## IDAHO DEPARTMENT OF LANDS DIRECTOR'S OFFICE

September 11, 2020

Subject: Application for Permit to Drill, Barlow #2-14, Payette Co., ID

FIGURE 1

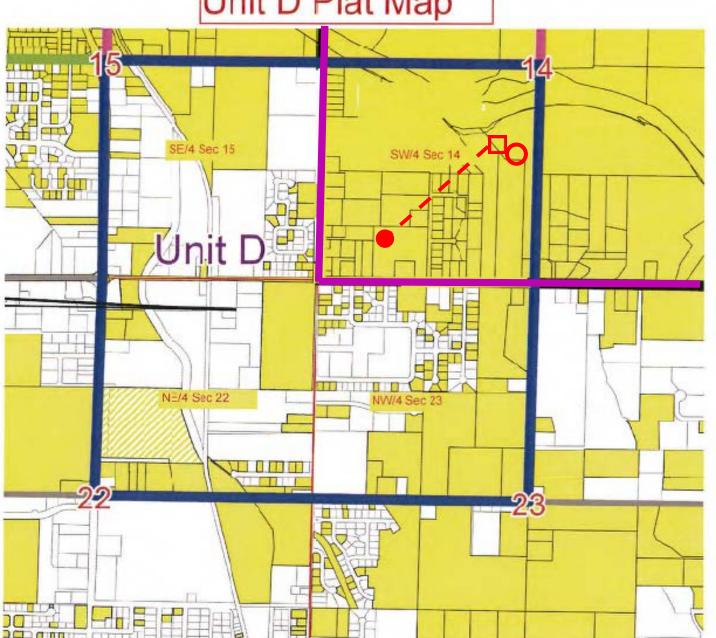
- In 2017, AM Idaho LLC applied for an Integration / Spacing unit for the proposed B Sand target. This 640-acre unit, referred to as Unit D, Docket CC-2017-OGR-01-001, encompassed Quarter-Quarter sections from four separate government sections, including the SW1/4 of Section 14 (Figure 1). The application was subsequently withdrawn, and the unit was not established. The Geologic Statement accompanying the application included a seismic amplitude map submitted in support of the geologic limits of the Sand B target, which appears to extend beyond section 14 (Figure 2).
- The Geologic Statement submitted with the application for permit to drill the Barlow #2-14 indicates the target sand as the "B" Sand in the SW1/4 of Section 14 (Figure 3). Based

Geologic Statement for CC-2017-OGR-01-001 (D. Smith) #4: Red circle in SE1/4 Sec. 15 is proposed target. #11 states the target is likely a combination structural/stratigraphic test at approx. 3185' TVD. Dark blue areas are interpreted to have no Sand B present.

#14 states that a large part of the pool lies outside the proposed location qtr-qtr section, including the W1/2 SW1/4 Section 14, so the overlapping 640-acre proposed Unit D is "more appropriate" to "prevent correlative rights and prevent waste."

The 2017 proposed Unit D for a Sand "B" target includes the SW1/4 of Section 14, the target area for the proposed Barlow #2-14.

FIGURE 2

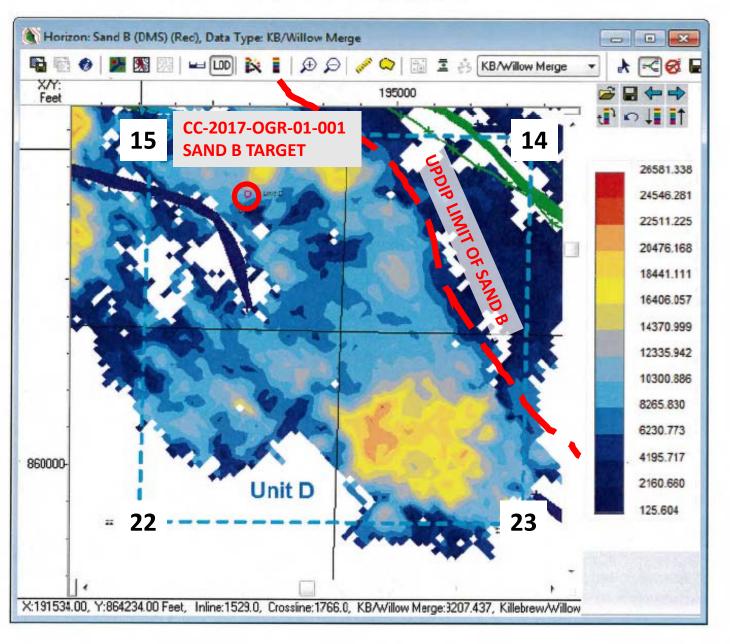
Barlow 2-14 target is a stratigraphic test of the "Sand B" interval which is completed in the Fallon 1-10 well to the northwest. Approximate proposed well path indicated by the dashed red line. The well is designed to test Sand B, then tag the Sand D interval in a downdip location, possibly for a stratigraphic control point.

The existing Barlow 1-14 (red circle) is completed in the "Sand D" interval. Sand B, the target interval for the 2-14, is not developed in the Barlow 1-14 well.
